## Planning and Zoning Commission

Date: April 6, 2021  
To: Planning and Zoning Commission  
From: Tarika Peeks, Director of Planning and Zoning  
Agenda Item: **2021035 – Everton Commons** – To allow a 12' encroachment in the 25' undisturbed vegetated buffer, which is a reduction of the buffer from 25' to 13' for approximately 352 LF.

WENDOVER HOUSING PARTNERS  
EVERTON COMMONS  
MULTI-FAMILY  
DEVELOPMENT  
FAIRBURN, GA

**Exhibit A**

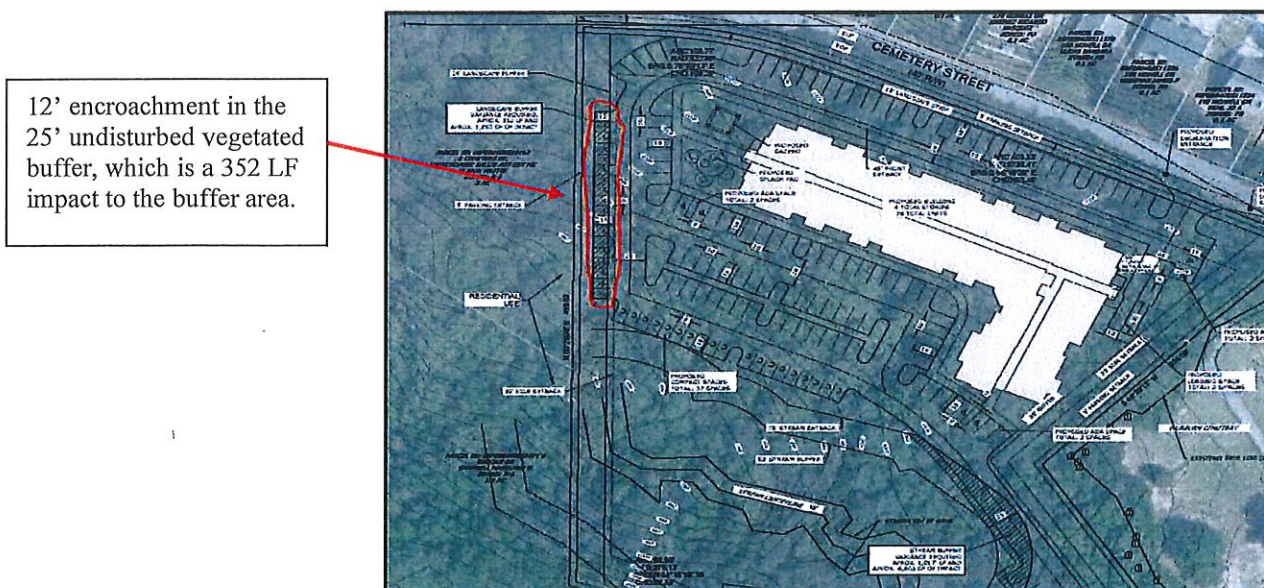
The applicants' request to reduce the buffer by 12' will not eliminate the entire buffer area; 13' of the buffer shall remain, resulting in adequate buffering between the adjacent properties. Also, the buffer encroachment only impacts 352 linear feet of the buffer, which is not the entire length of the buffer area. The remaining 25' buffer located on the west side of the subject property will not be impacted and the remaining buffer will provide a visual obstruction of the adjoining property. See Exhibit A below.

Relief from the 25' undisturbed vegetated buffer requirement by 12' in the area identified by the applicant will not jeopardize harmony with the general purpose and intent of Chapter 80. Zoning, Article X – Buffer and Open Space. Staff is of the opinion that granting the variance would not adversely affect the adjacent properties and cause any potential nuisances associated with use of the subject property because a large portion of the buffer will remain; only 352 LF of the buffer will be impacted, which allows majority of the buffer to remain intact.

Staff has reviewed the request for relief as it pertains to the variance considerations in Section 80-251 of the City of Fairburn Zoning Ordinance. Based upon this review, staff recommends **APPROVAL** of the primary variance request to allow a 12' encroachment in the 25' undisturbed vegetated buffer, which is approximately 352 LF.

CONCEPTUAL SITE  
PLAN LAYOUT  
ISSUE:  
DATE:  
04-10-2020  
JOB NO.:  
DESIGN:  
DRAWN:  
CHECKED:  
SHEET NO.  
C-100

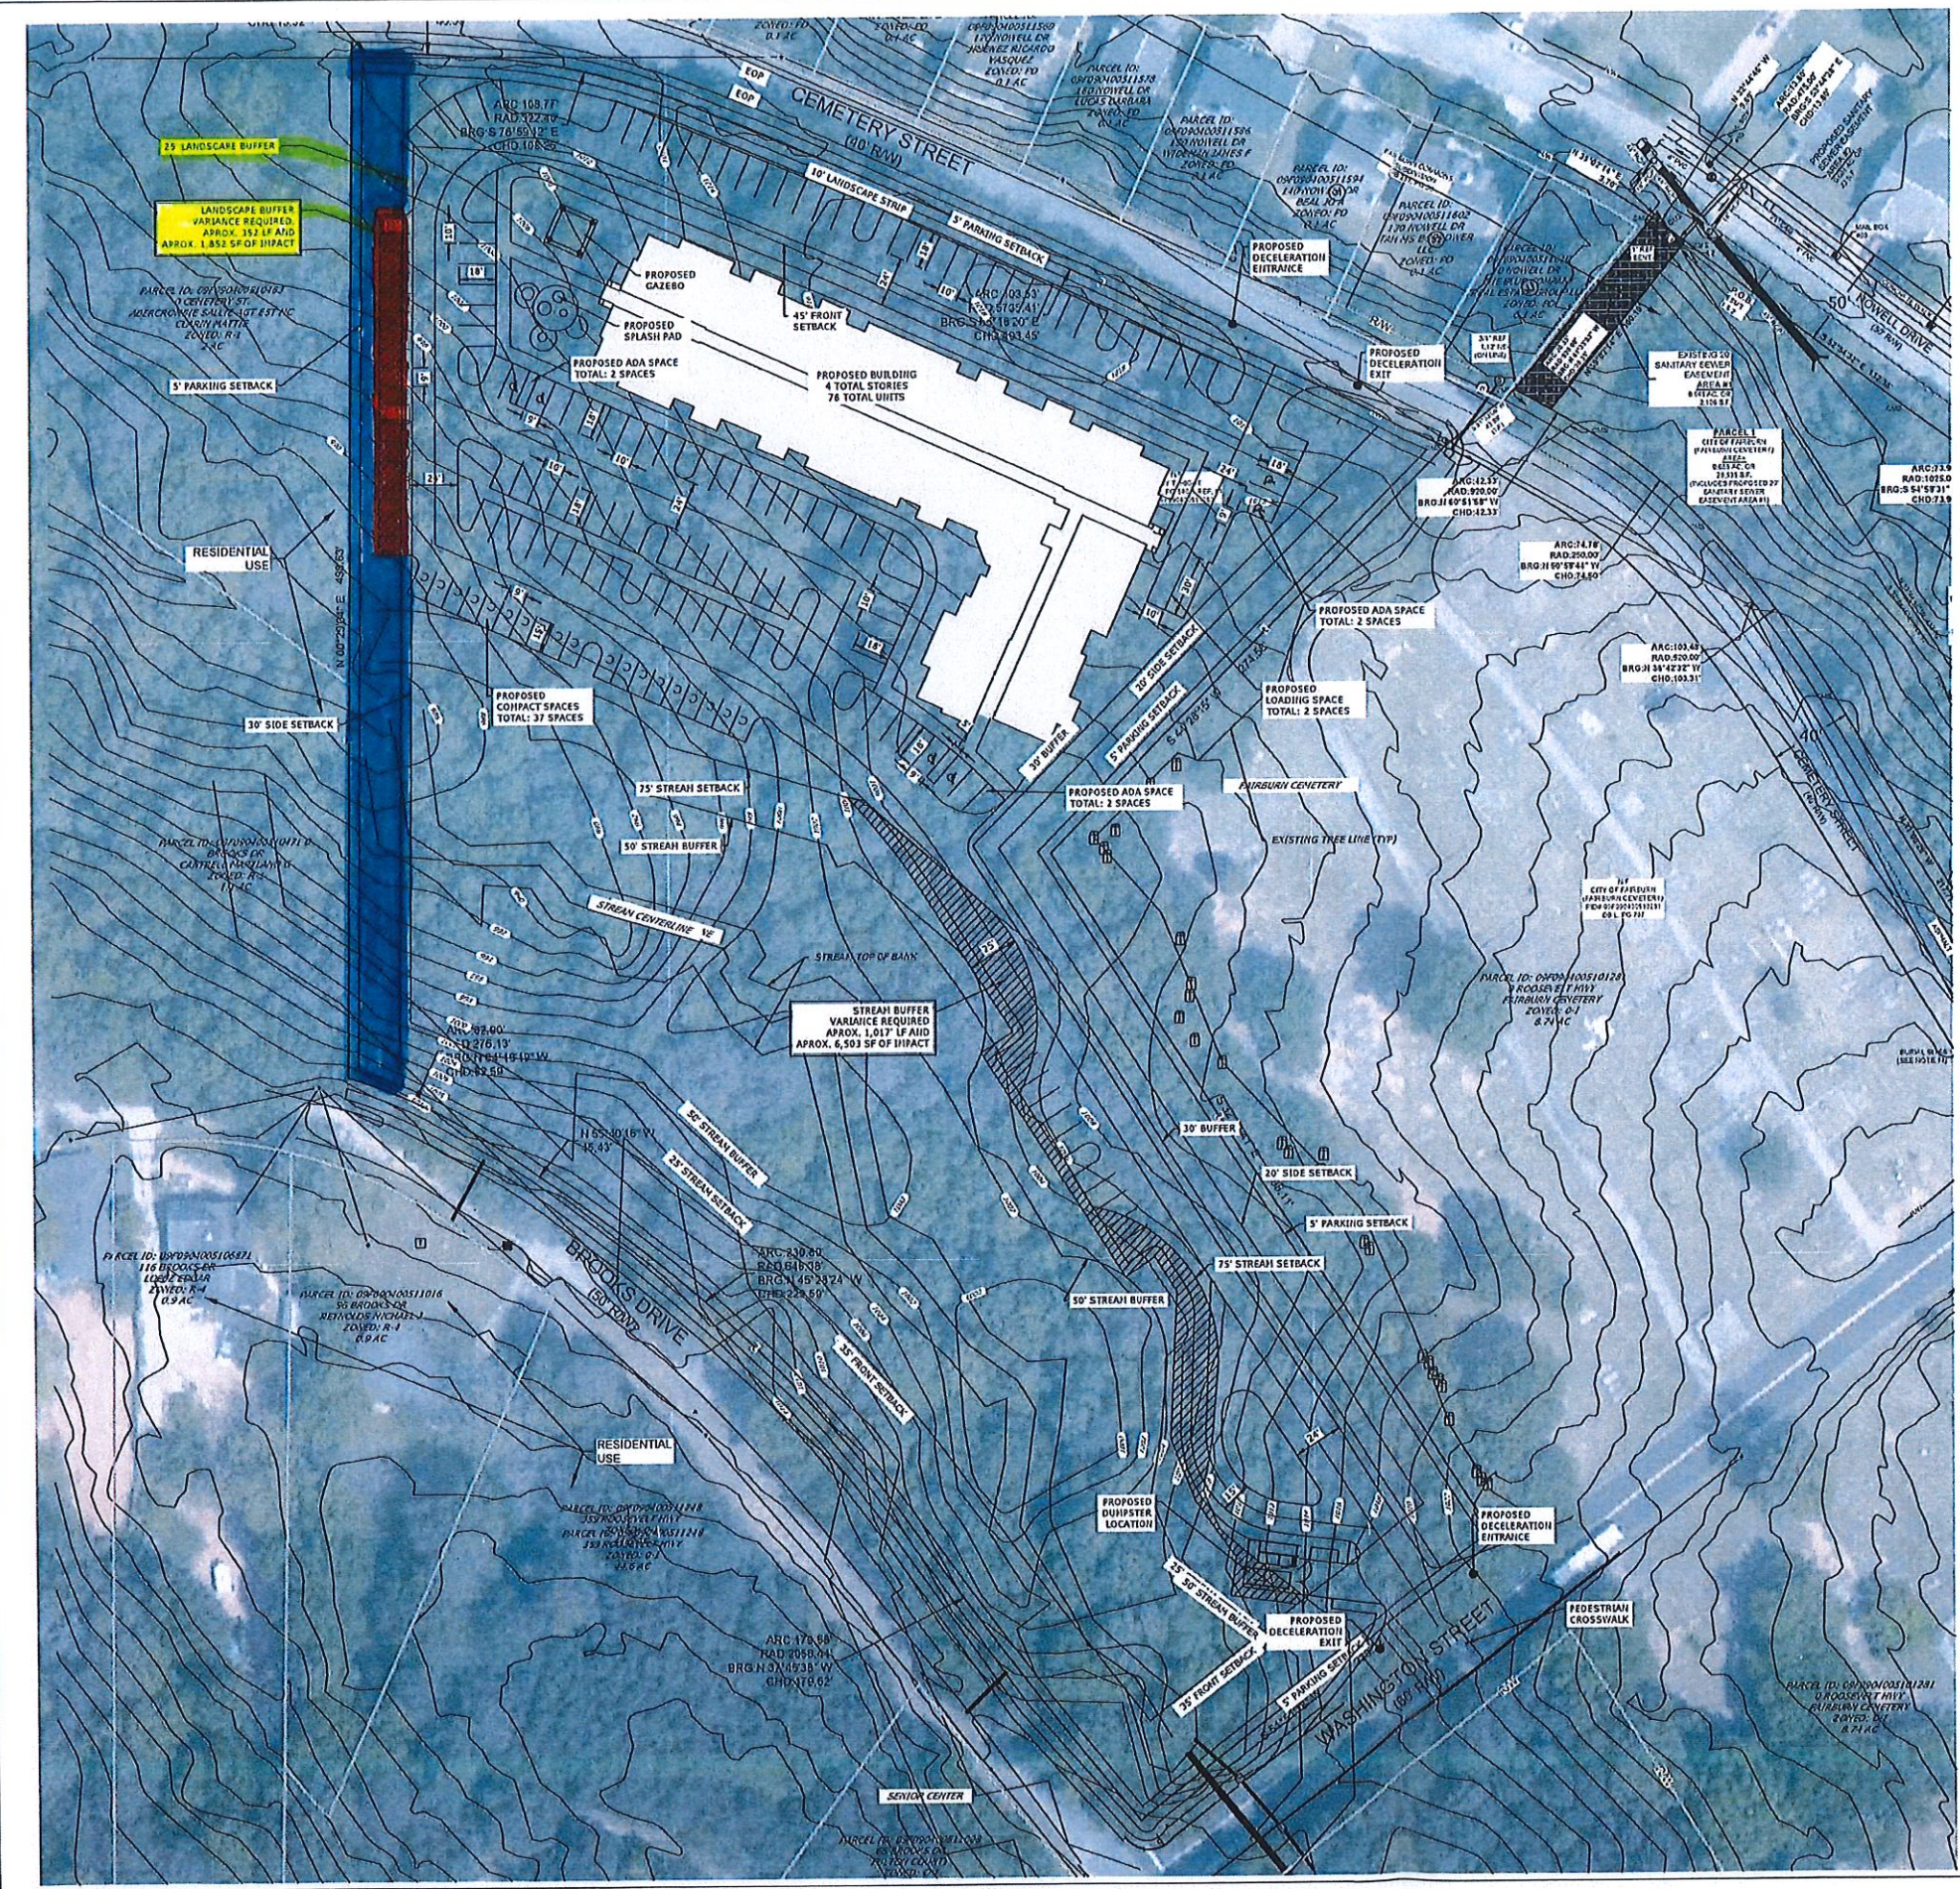
Note: The red color represents the 12' [352 LF] encroachment in the 25' buffer and blue color represent the 25' buffer area.
